WESLEY STATION SUBDIVISION

Revised for the February 3, 2011 meeting.

APPLICATION NUMBER 2 DATE February 3, 2011

DETAIL SITE PLAN

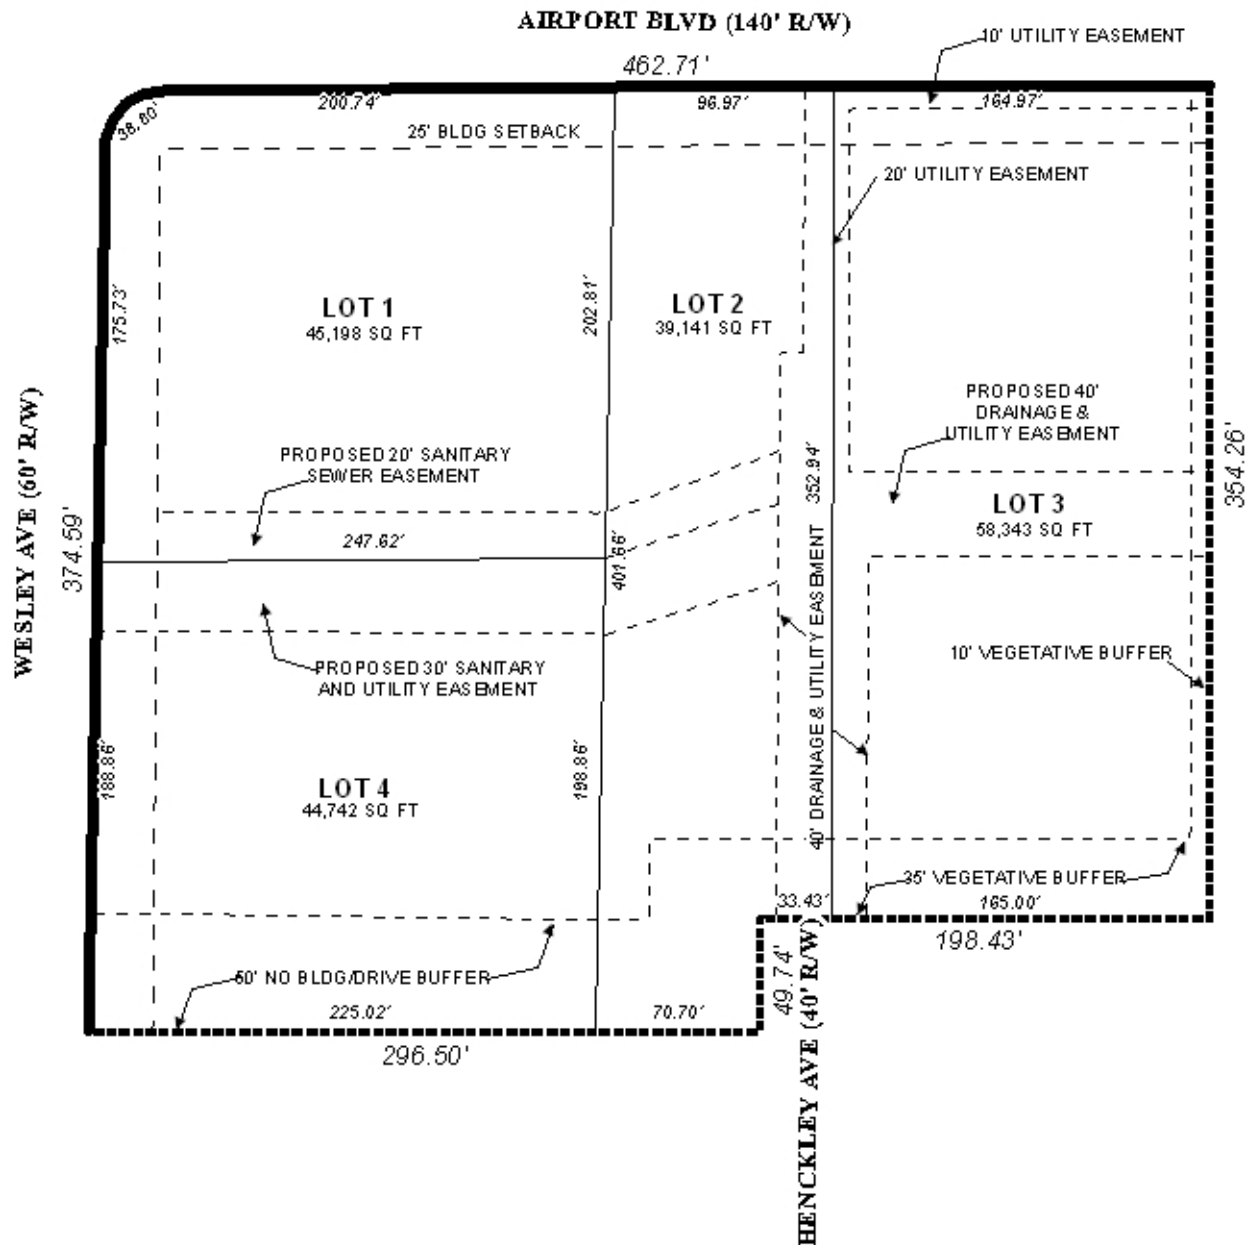
The subdivision was originally recorded with drainage and utility easements running both North-South, and East-West through the site. The West half of the East-West easement is proposed to be relocated from the Northern third of the site to the middle of the site to line up with the Eastern portion of the East-West easement. The recorded easement proposed to be relocated was vacated by City Council Resolution #47-548 on December 7, 2010. The plat indicates the relocated easement as two parallel easements along a proposed lot line with the Northern portion for sanitary sewer and the Southern portion for drainage and utilities.

The proposed lots, as depicted, meet the minimum size and frontage requirements as regulated by the Subdivision Regulations. Proposed Lot 2 exceeds the maximum depth ratio of Section V.D.3. of the Subdivision Regulations. The lot area size is not depicted on the plat in square feet, and this information should be shown on the Final Plat, if approved. The 25-foot minimum building setback line is not depicted, and this should also be shown along all public street frontages on the Final Plat, if approved.

The previously required 50-foot no-build buffer, the 35-foot vegetative buffer, the 10-foot vegetative buffer, and the 25-foot building setback line along public streets are shown on the preliminary plat, and should also be shown on the final plat, if approved. A note should also be placed on the final plat stating that no structures, parking or driveway(s) may be constructed within the Southern 50 feet of Lots 2 and 3 between Wesley Avenue and Henckley Avenue.

The previously required 8-foot high wood privacy fence is not depicted or included as a note on the plat, thus the plat should be revised to also depict and note that an eight-foot high wooden privacy fence and vegetative buffer should be provided where the site adjoins residential zoning.

- 1) the provision of an eight-foot wooden privacy fence and vegetative buffer where the site adjoins residential zoning;
- 2) placement of a note on the final plat stating that no structures, parking or driveway(s) may be constructed within the southern 50 feet (between Wesley Avenue and the West right-of-way line of Henckley Avenue);

- 3) depiction and labeling of the 35-foot vegetative buffer along the Southern boundary of the site, from the West right-of-way line of Henckley Avenue, as shown on the preliminary plat;

- 4) depiction and labeling of the 10-foot vegetative buffer along the eastern boundary of the site, as shown on the preliminary plat;
- 5) compliance with Engineering comments: *(Must comply with all storm water and flood control ordinances. Any increase in impervious area in excess of 4,000 square feet will require detention. Any work performed in the right of way will require a right of way permit. Drainage from any new dumpster pads cannot discharge to storm sewer; must have connection to sanitary sewer).*

- 6) placement of a note on the final plat stating that Lot 1 is limited to one curb-cut, and Lots 2 and 3 are limited to one shared curb-cut, for a total of two curb-cuts onto Airport Boulevard, and Lots 1 and 4 are each limited to one curb-cut onto Wesley Avenue, with the curb-cut on Lot 4 as far North as possible, with the size, design and location of all curb-cuts to be approved by the Planning Section of Urban Development and Traffic Engineering, and comply with AASHTO standards;

- 7) placement of a note on the final plat stating that access to Henckley Avenue and the unopened right-of-way of Government Street is denied;
- 8) labeling of each lot with its size in square feet, or placement of a table on the plat with the same information; and
